**ZONING AMENDMENT &
PLANNED UNIT DEVELOPMENT
STAFF REPORT**

Date: August 2, 2007

Paul Persons

4474 Halls Mill Road
(North side of Halls Mill Road, 4/10 mile+ West of the
North terminus of Riviere du Chien Road)

SITE PLAN

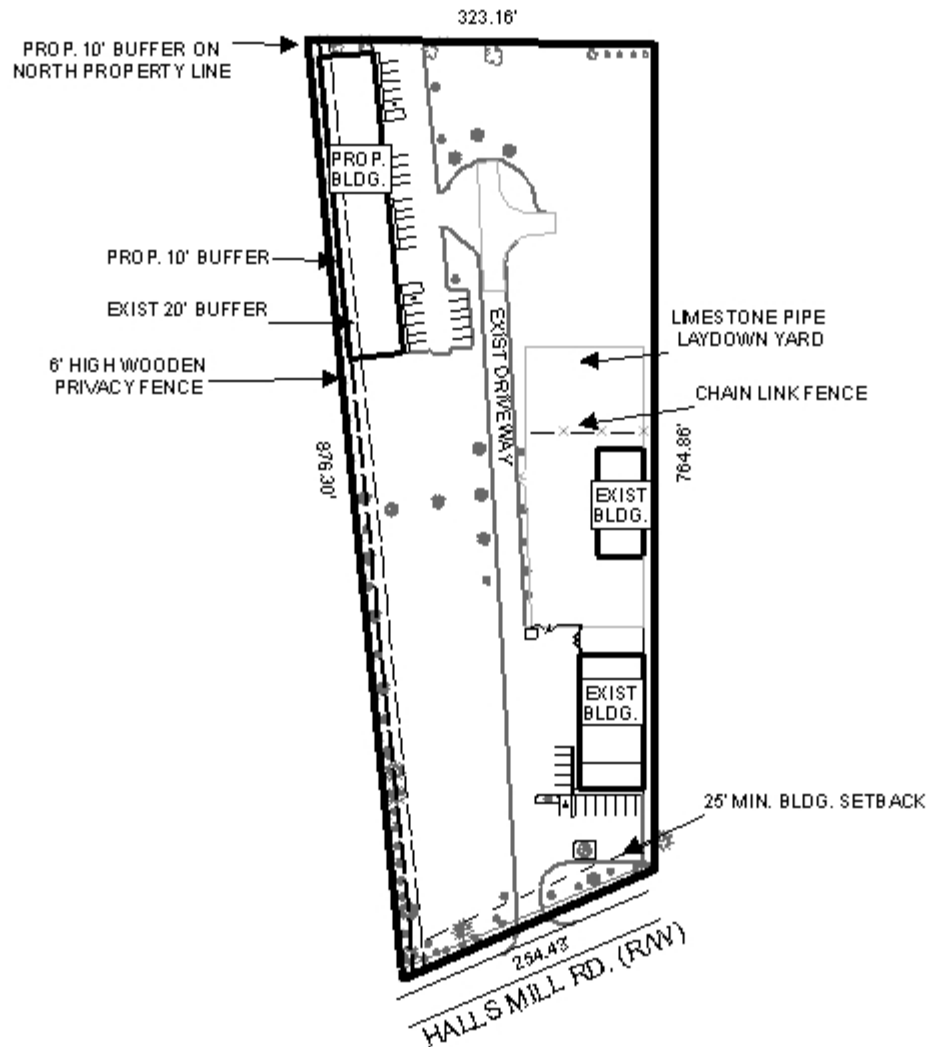
The proposed building will be set back 10 feet from the North and West property lines, thus the reason for the rezoning application requesting a reduction in the 20-foot wide buffer condition from 1997. The site plan includes a note stating that the North boundary line would include substantial buffering with existing and new landscaping and trees, or a 6-foot high privacy fence as part of the proposed 10-foot wide residential buffer. A 6-foot high wooden privacy fence is shown as existing along the Western boundary line of the property, where it abuts the apartment complex in a B-1 district.

There is no indication on the site plan as to the proposed location of any dumpster or other waste storage facility. If the applicant utilizes a dumpster, the location of the storage area for the dumpster must be indicated on the site plan, and the location and required screening must comply Section 64-4.D.9. of the Zoning Ordinance, as well as with all other applicable regulations.

There have been no changes to the surrounding residential uses to warrant changing the previously approved buffer requirement. It is clear that reducing the buffer would benefit the proposed development, however, there appears to be adequate land available on the property to accommodate the buffer requirements through a redesign of the proposed development.

Rezoning: Based upon the preceding, this application is recommended for Denial for the following reasons:

- 1) Conditions do not appear to have sufficiently changed to warrant the removal of the buffer condition; and
- 2) The applicant has not sufficiently justified the reduction of the proposed buffer, other than to accommodate the proposed development.

- 1) based upon the denied Zoning application, and thus the remaining 20-foot buffer requirement.
